ROAD SAFETY INSPECTION

Spencers Brook Road Slk 3.26 –
23.87

Report Issue Date: **8/06/2018**

Revision 1

2.5 Finding – Intersection Warning Signs

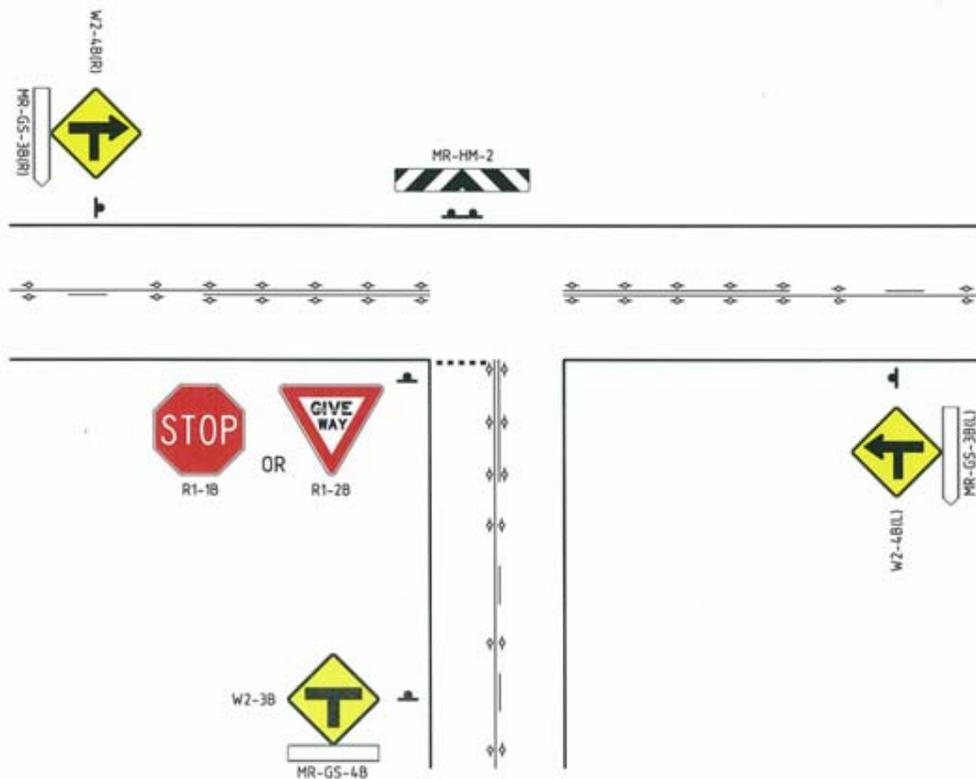
MRWA guideline drawing 201031-0008 shows the recommended typical intersection sign and device installation. It was observed that most intersections within the audit scope do not have the recommended installation of signs and devices.

Installing the recommended signs and devices (including RRPM's and holding lines) will highlight the presence of the intersection to road users. Displaying the side road name in advance of the intersection may also reduce road users reducing their speed around intersections trying to identify the road name.

Install the recommended signs and devices (including RRPM's and holding lines) in accordance with MRWA requirements at all intersections (note use of MR-HM-2).

2.19 Finding – Curved Alignment Markers

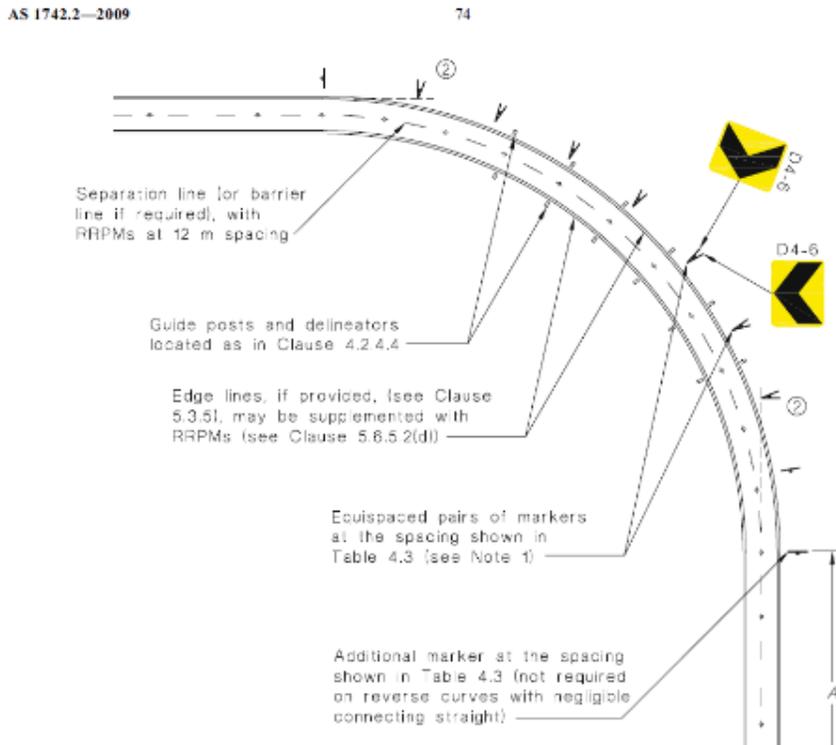
The Curved Alignment Markers near Slk 23.65 are incorrect.

The correct Curved Alignment Markers are more prominent than the markers which are installed.

Install the correct Curved Alignment Markers in accordance with AS1742.2 and MRWA requirements.
